**Improving the Ground Transportation  
Infrastructures near  
Montréal-Trudeau Airport**

**Environmental Impact Study  
Submitted to the Minister of the Environment**

**SUPPLEMENTARY INFORMATION  
PROJECT AND IMPACT MODIFICATIONS**

*DAA project: 25023H*

**Figure 1: Rail right-of-way**

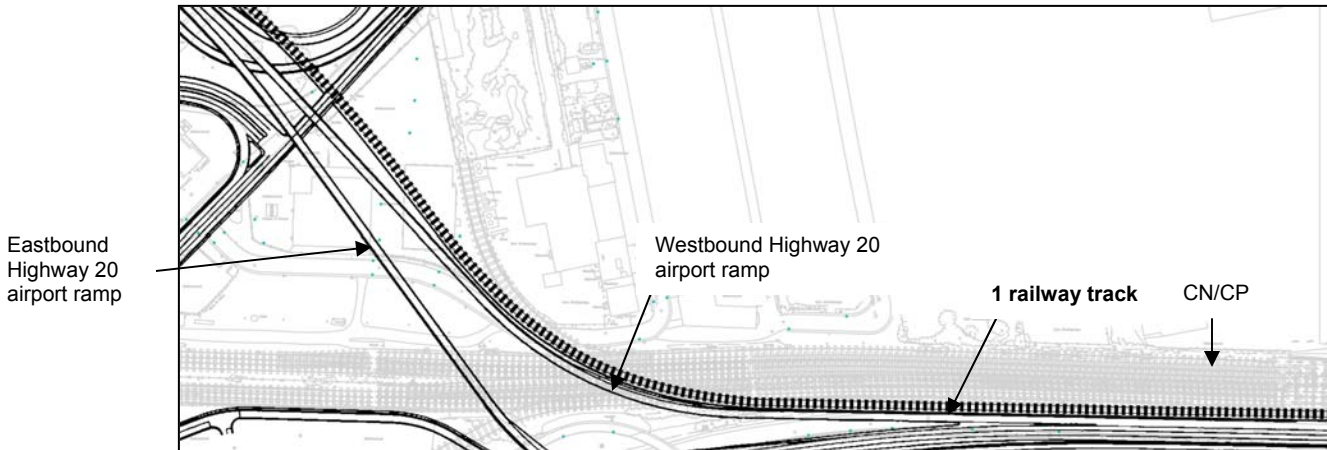
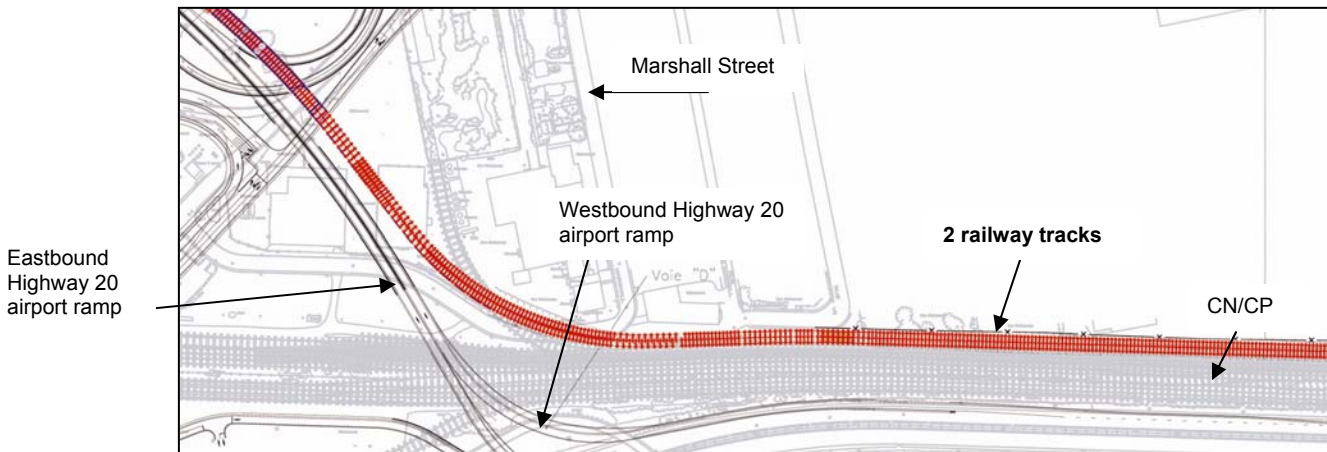
Based on the preliminary results of the feasibility studies that were carried out by ADM and VIA Rail, the rail right-of-way will include two tracks built north of the existing CN/CP tracks. The original plan involved a single track south of the CN/CP tracks. As a result of, the rail link no longer has to go through a tunnel under the existing tracks.

With respect to the profile of the track, the two new tracks will have an elevation that is similar to that of the existing ones, which are on a low rail embankment, running from the eastern boundary of the territory near Orly Street to Marshall Street. The tracks will change alignment starting at Marshall, and will descend into a trench that leads to the new station that will be built near the air terminal.

- Only the route to the north of the existing tracks provides the option of adding new tracks in order to ensure the reliability of the shuttle (schedule). With the route to the south, no additional tracks could be built because of the proximity of Highway 20, and another track between the CN and CP tracks is not feasible;
- This route is the best choice in terms of potential conflicts between passenger trains and freight trains, because they will be separated;
- This route also creates the possibility of 20-minute shuttle service;
- This route appears to be the least costly.

**Figure 2: Westbound Highway 20 airport ramp**

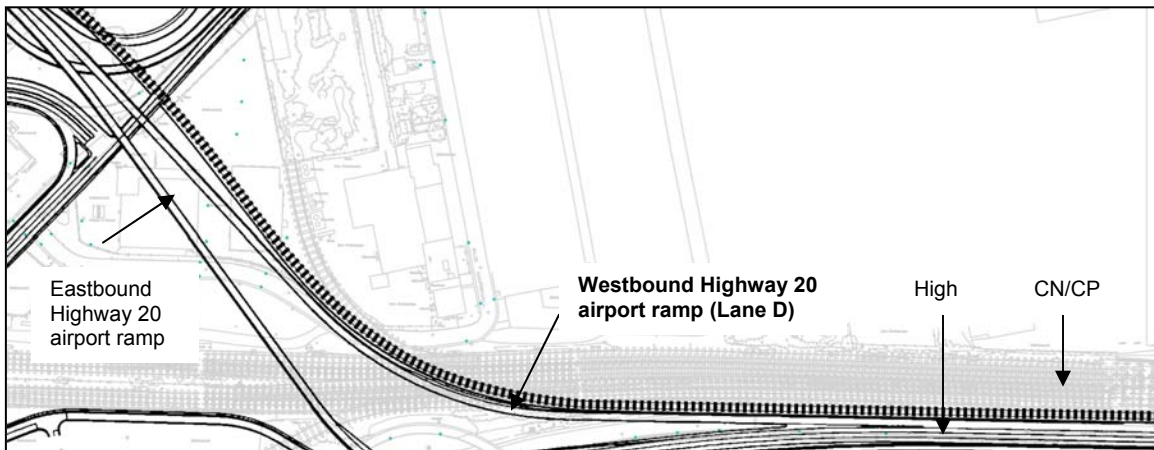
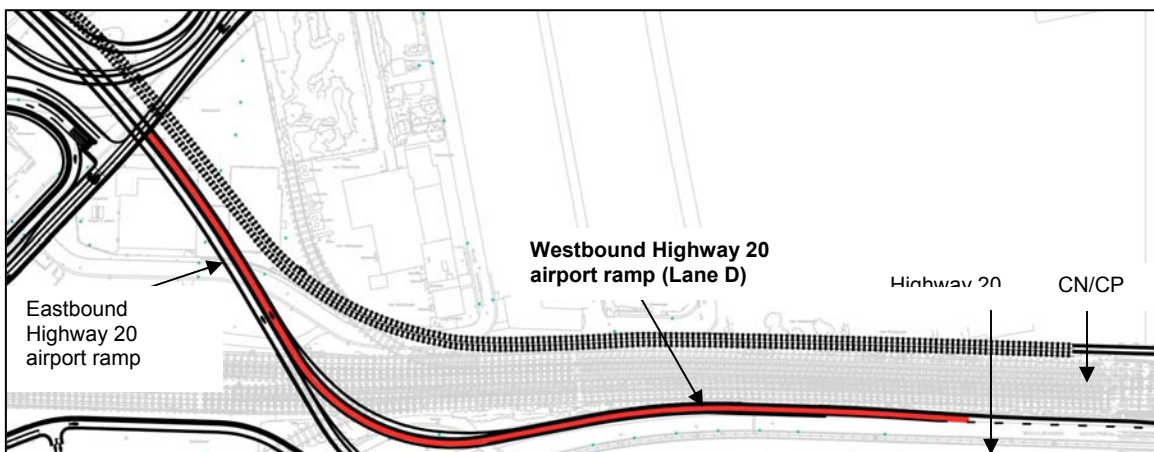
Since the railway tracks will be built north of the existing CN/CP ones and construction of a tunnel is no longer necessary, there is no point in building the new ramp from westbound Highway 20 to the airport (Lane D) sunken under the tracks. Lane D will therefore be elevated and shifted slightly southwest close to the ramp from the airport to eastbound Highway 20 (Lane C) to minimize construction costs. Note that Lane D's profile will resemble Lane C's. A related advantage is streamlining the structures by joining Lanes C and D along part of their routes.

**Figure 3: Westbound Highway 20**

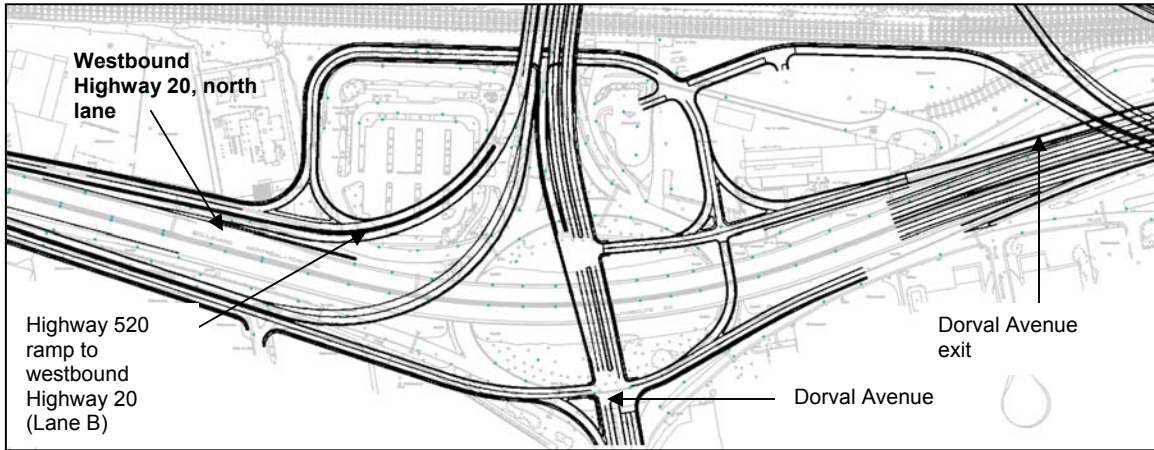
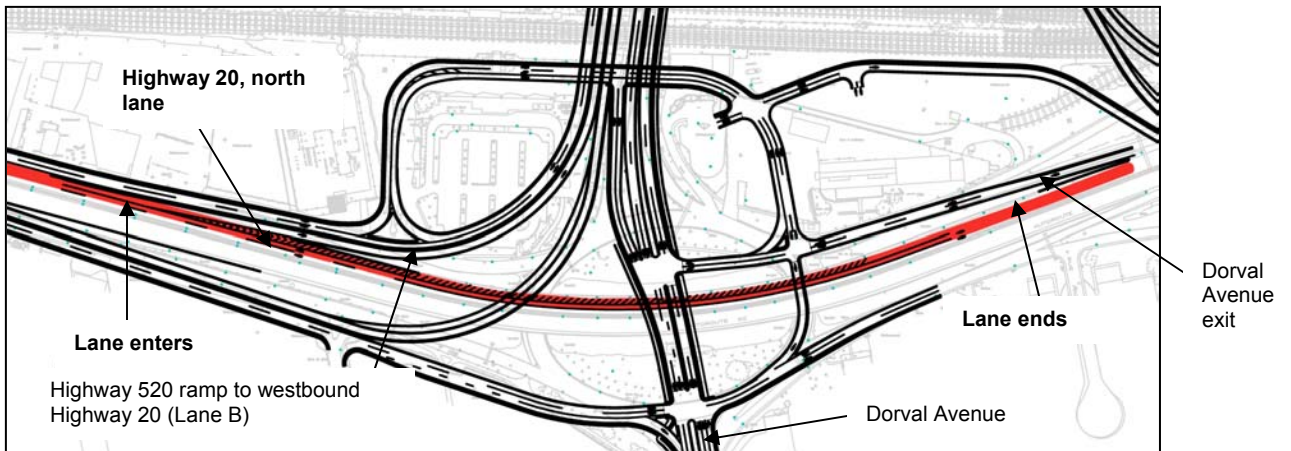
A modification was needed in order to facilitate safe merging of the vehicles coming from westbound Highway 520 (Lane B) with those on Highway 20. In light of this, the right-hand lane on westbound Highway 20 (north side) will end at the Dorval Avenue exit (northeast service road). Beyond the exit, the right-hand lane merges with the middle lane, reducing the highway from three lanes to two lanes beyond that point. West of Dorval Avenue, the on-ramp from westbound Highway 520 joins the two lanes, creating a third lane from a dedicated entrance. While the main reason for changing the original design was a safety improvement, this modification also has the advantage of avoiding expropriation of a strip of land from the properties located along the northwest service road.

**Figure 4: Traffic coming from westbound Highway 520 toward Highway 20 and from Michel-Jasmin Avenue toward westbound Highway 20**

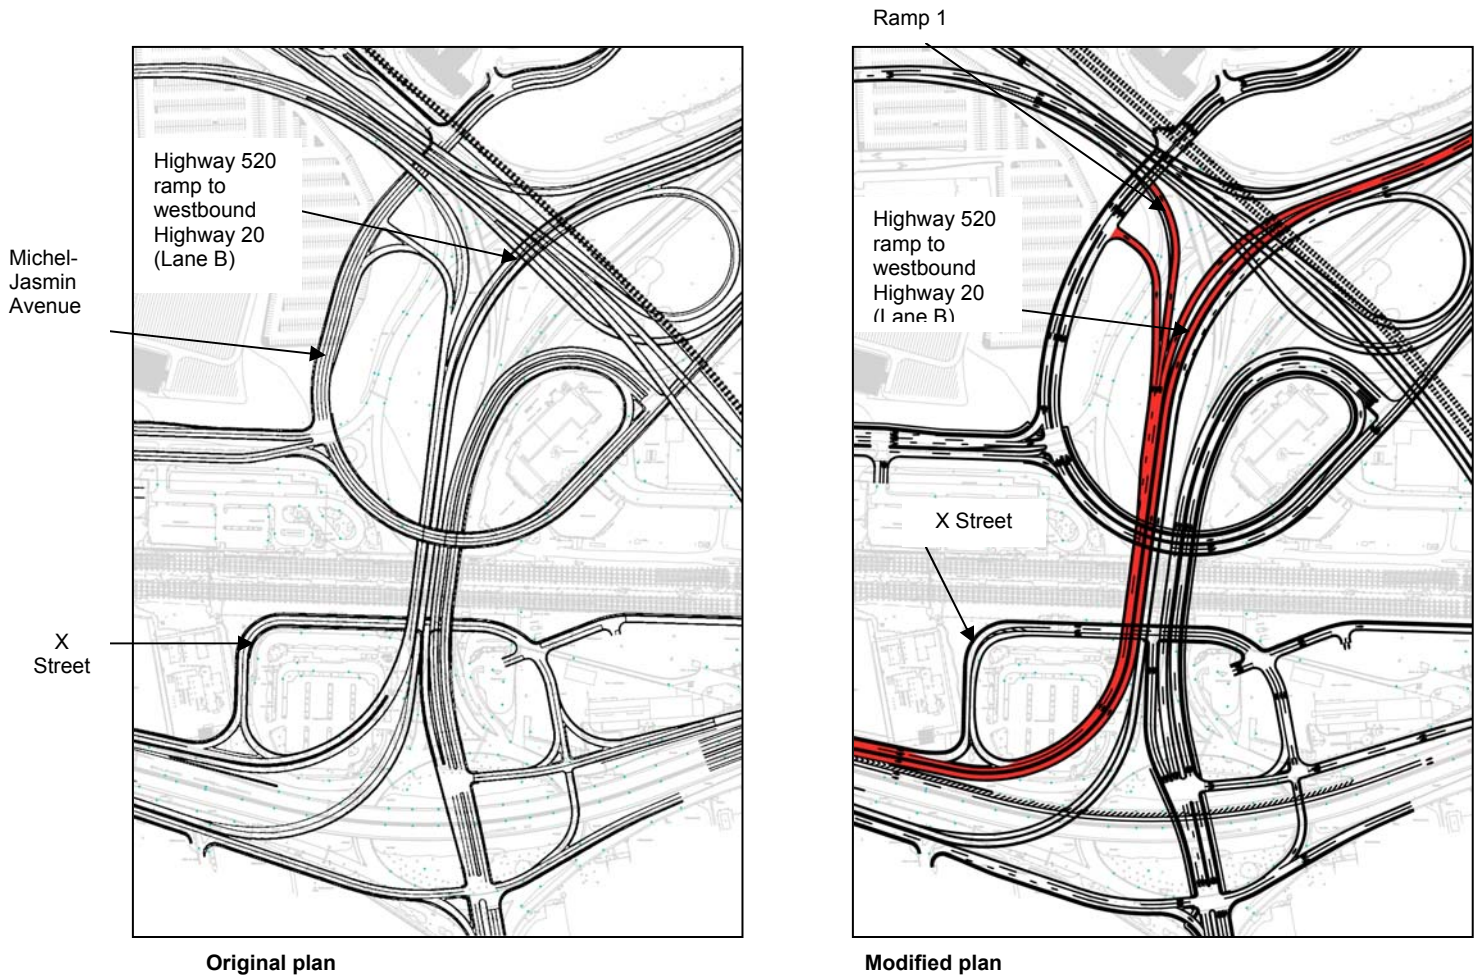
The modified plan calls for physically separating the traffic coming from westbound Highway 520 toward westbound Highway 20 (Lane B) from local traffic coming from the airport (Ramp 1) and Michel-Jasmin Avenue. This modification aims to improve functionality over the original design, which would have meant rapid merging followed by a stretch of weaving that could cause safety problems. These two features have been eliminated in the modified plan, which allows for the safe flow of vehicles coming from the airport on Ramp 1, coming from Michel-Jasmin Avenue, and coming from Highway 520.

The route for vehicles coming from the airport or from the entrance from Michel-Jasmin Avenue toward westbound Highway 20 on Ramp 1 has been slightly altered. In the original plan, these vehicles could directly enter Lane B, and then westbound Highway 20, whereas in the modified plan, they must take the northwest service road in order to enter Highway 20. The distance that they have to travel remains the same. The total number of vehicles affected by the route changes in 2016 will be approximately 175 per hour during the morning rush, and 265 per hour during the evening rush.

**Figure 6: New local street ("X") and added lane**

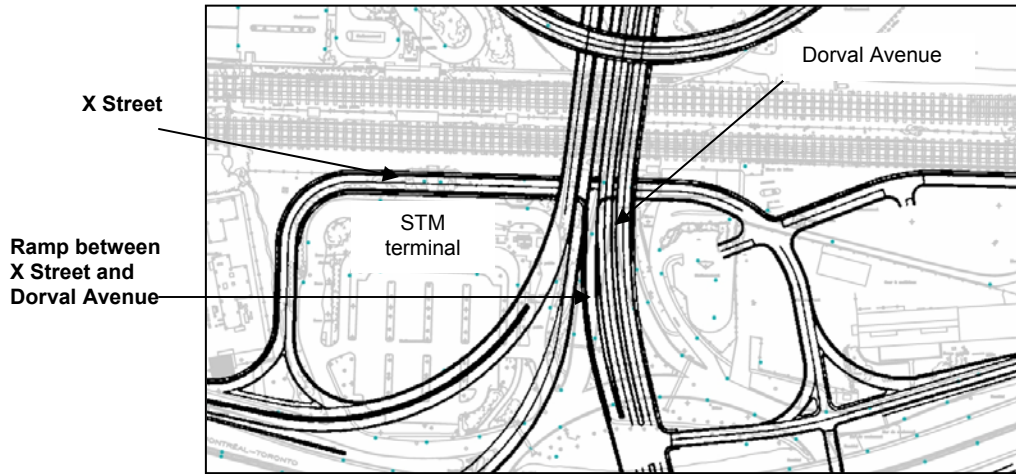
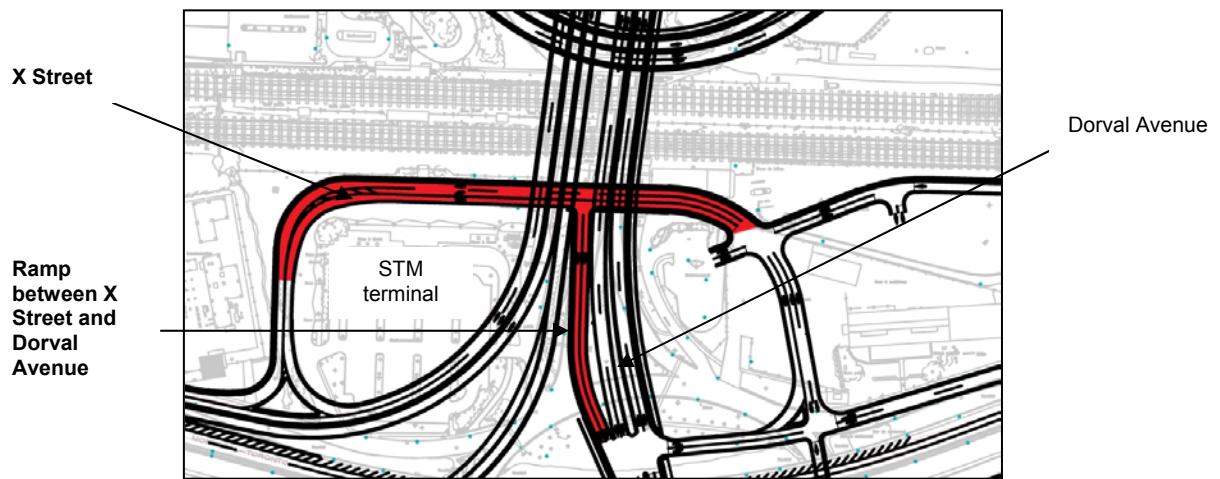
The new route for X Street calls for an additional westbound lane in order to allow for safe left turns to access the bus terminal and incentive parking (see Figure 6). These turns can also be made without blocking the flow of vehicles continuing on toward the northwest service road.

A second lane has been added to this ramp for two reasons. First, increasing the effective width will make right turns off X Street easier for southbound buses coming from the STM terminal. Second, the capacity of the Dorval Avenue/northeast service road intersection at the end of the ramp will be increased by the extra lane, which will mean that it will be capable of handling the projected traffic in 2016.

**Figure 7: Cardinal Avenue and the Cardinal/Michel-Jasmin intersection**

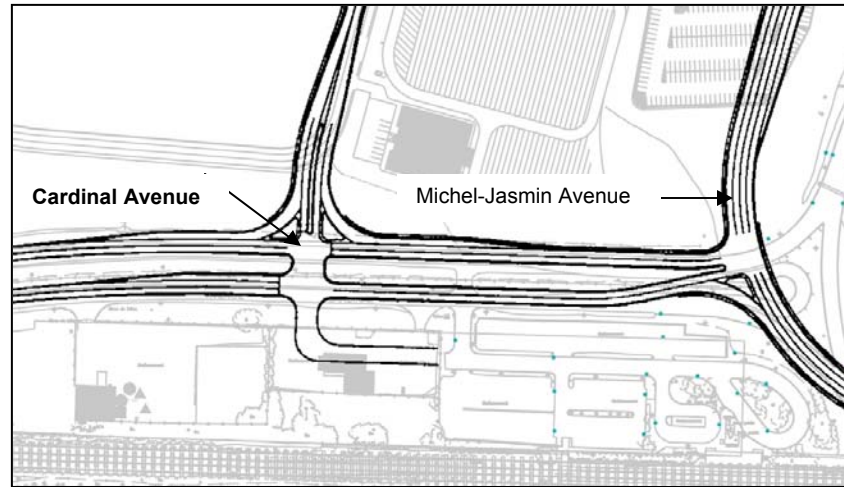
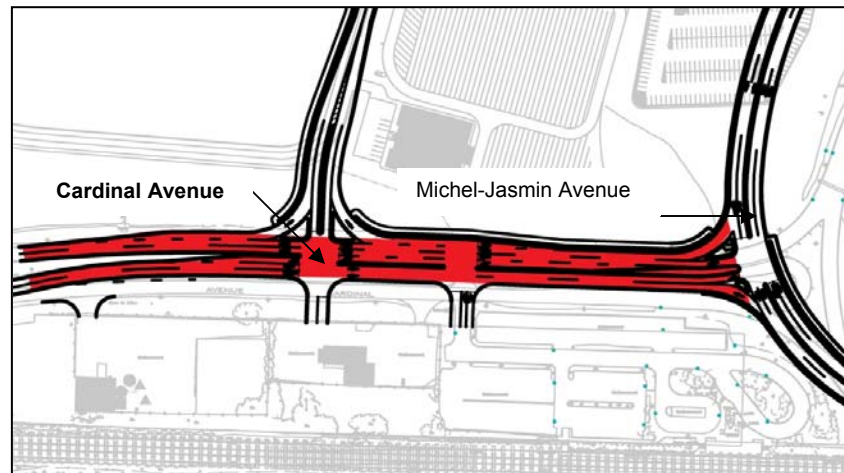
In the modified plan, the axis of the south side of Cardinal Avenue (eastbound) is shifted toward the north side. This change to the route maximizes the area of the land along the south side of Cardinal Avenue. In particular, the increased area will make land available for other uses. This route also allows for a number of design options for improving the city gateway.

The Cardinal/Michel-Jasmin intersection is slightly altered in the modified plan. In fact, there was a discontinuity for southbound traffic in the original plan, where two lanes ended up facing a single lane beyond the circle. The modification restores continuity (two lanes continue). A turn island has also been added to the northern approach to the intersection in order to handle the heavy traffic flow in that direction.
